Proposed Temporary Public Vehicle Park for Private Car for a Period of 3 Years at Lots 389 RP, 395 S.A, 395 RP, 396 S.A, 396 RP & 398 RP in D.D. 78, Lin Ma Hang Road, North, N.T.

**Compliance with Approval Condition (d)
Proposed Temporary Public Vehicle Park (Private Car Only) for a
Period of Three Years at Lot 389 RP, 395 S.A, 395 RP, 396 S.A, 396
RP and 398 RP in D.D. 78, Ta Kwu Ling North, New Territories**

Response to DSD's comments - Proposed Temporary Public Vehicle Park (Private Car Only) for a Period of 3 Years and Associated Filling of Land in "Agriculture" and "Village Type Development" Zones, Lot 389 RP, 395 S.A, 395 RP, 396 S.A, 396 RP and 398 RP in D.D. 78, Ta Kwu Ling North (Application No. A/NE-TKLN/80)

Figure 3

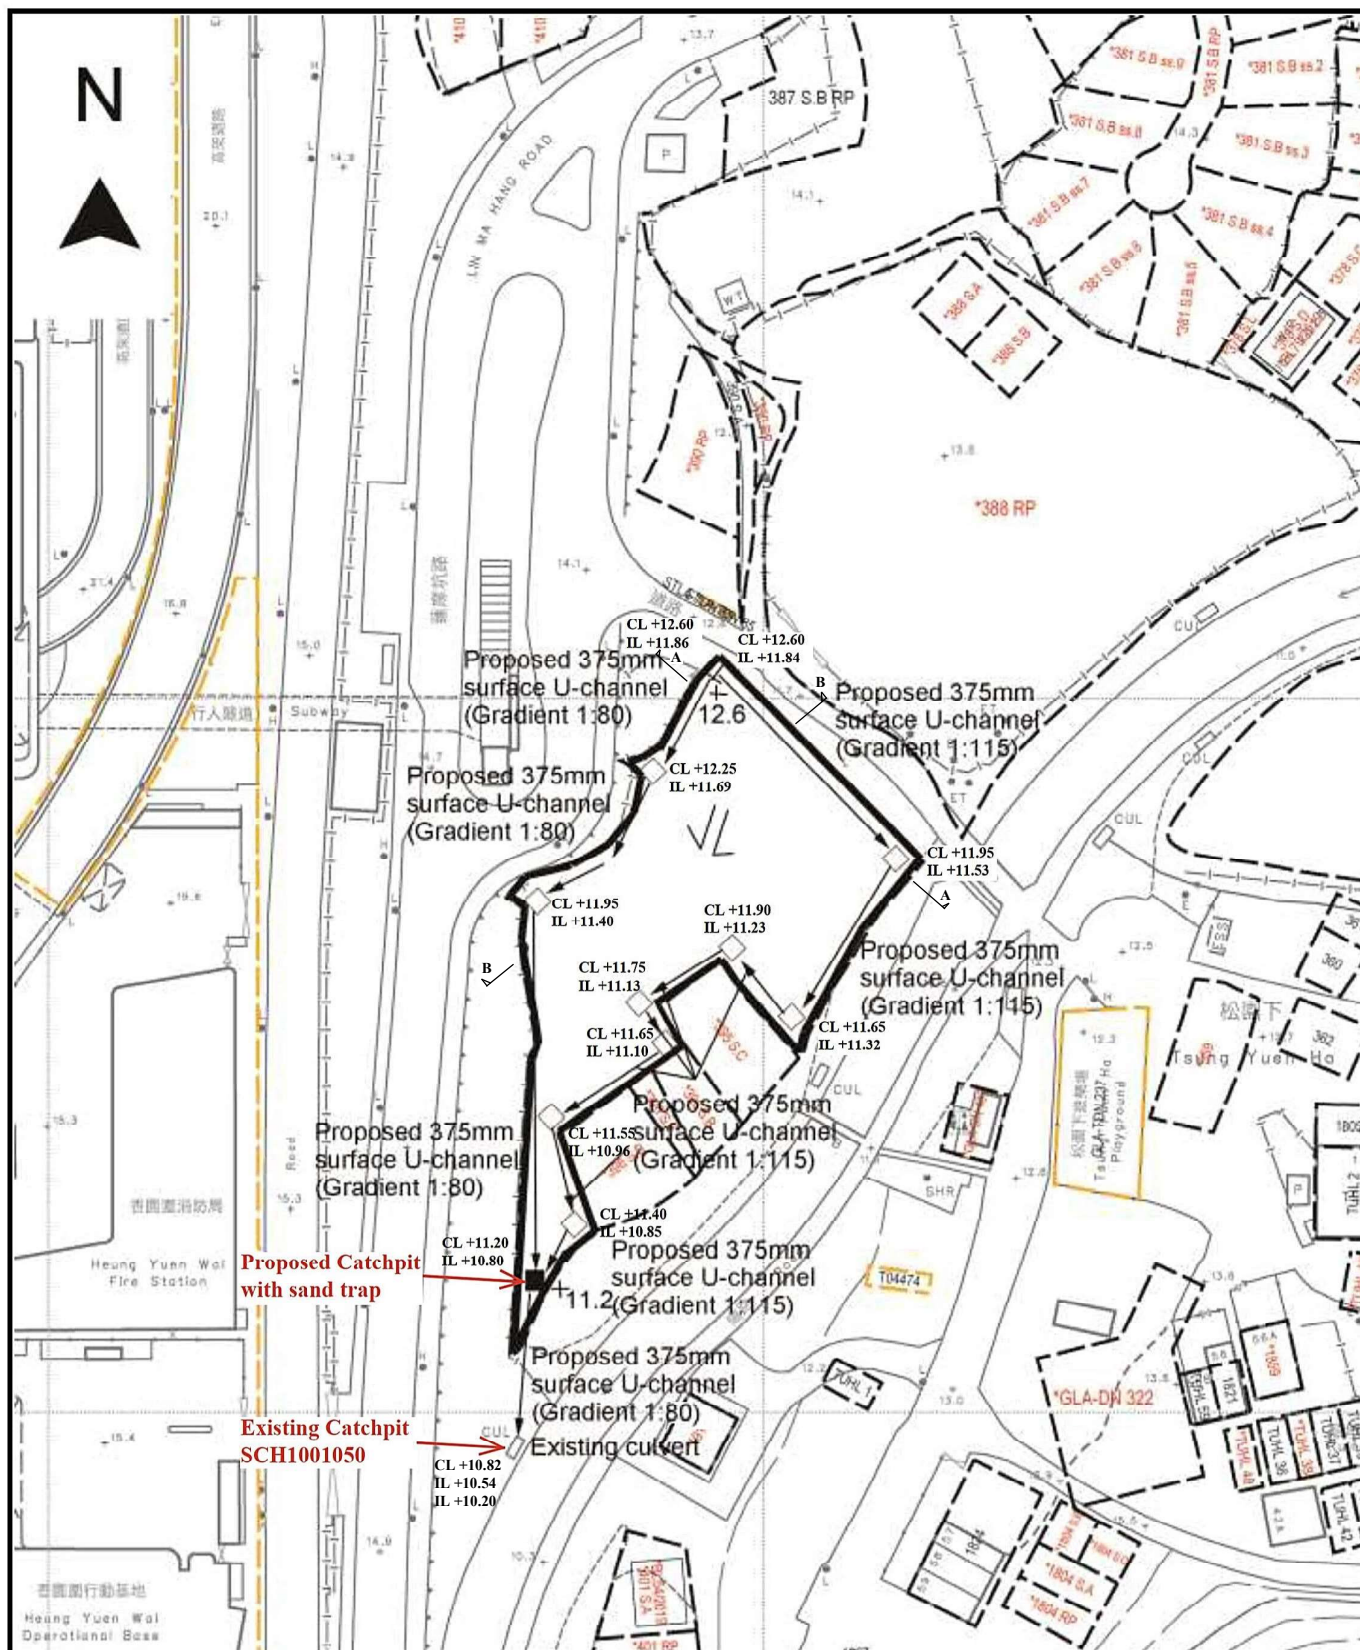
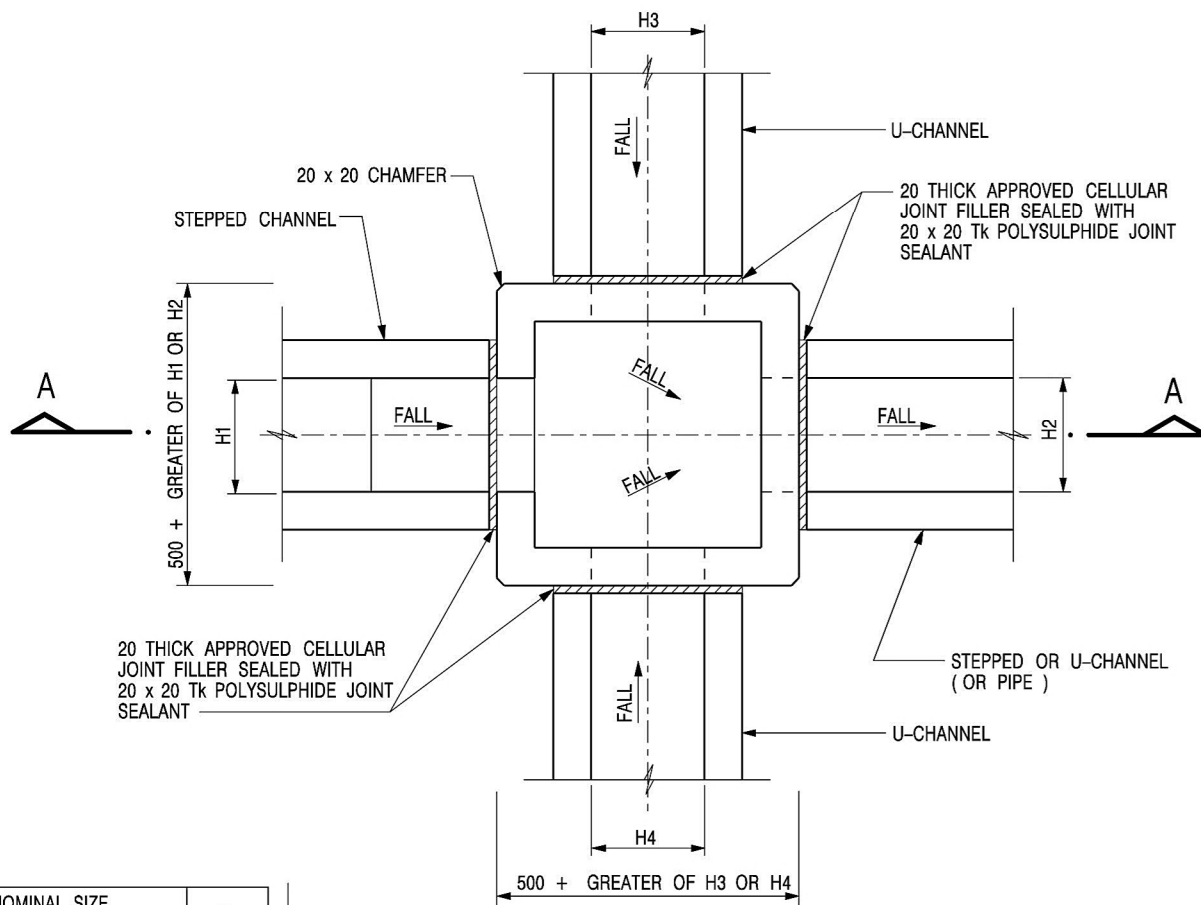
(xiv) the existing drainage facilities, watercourse, river, channel and the like should not be affected and obstructed by the construction materials, waste or debris from the proposed development;	Noted.
(xv) the applicant is required to provide sectional views of the site in 2 different directions showing clearly any walls would be erected or kerbs would be laid along the boundary of the site, the proposed and existing drainage facilities, flow direction, the existing ground level of the adjacent lands and the formation level of the subject sites for our reference;	As replied in previous RtoC, chain link fence will be built along the boundary of the site, and no wall or kerb will be erected/laid along the boundary of the site. The sections are shown in Figure F & G.
(xvi) the applicant should indicate the invert levels of the proposed inlet and existing outlet at existing catch pit SCH1001050;	The inverted levels of the proposed inlet and existing outlet at existing catchpit SCH1001050 are shown in Figure 3.

(xvii) the applicant should review if the drainage capacity of 375mm UC in a gradient of 1:115 between proposed catch pit with trap and existing catch pit SCH1001050 is adequate as its upstream is a 375mm UC in a gradient of 1:80; and	The gradient for U-channel between proposed catchpit with trap and existing catchpit SCH1001050 has been revised and shown in Figure 3.
(xviii) the applicant should supplement typical details for catch pit.	The typical details for catchpit is attached in Figure D and E.

Figure 3

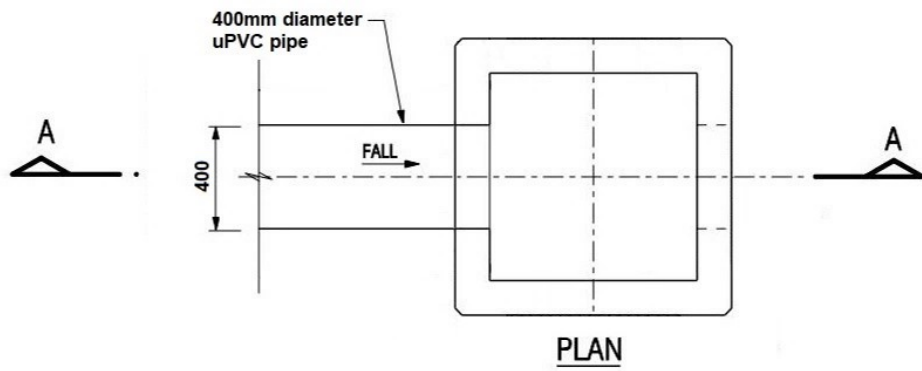
In order to suit the actual site condition, the channel connected from the last catchpit withn sand trap to the existing catchpit (SCH1001050) has been revised from 375mm U-channel to 400mm diameter uPVC channel. Since the cross section area of 400mm diameter pipe is larger than 375mm U-channel, therefore, the capacity of the proposed uPVC pipe is adequate. The revised drawing and details are shown in the enclosed Figure 3 and Figure D.
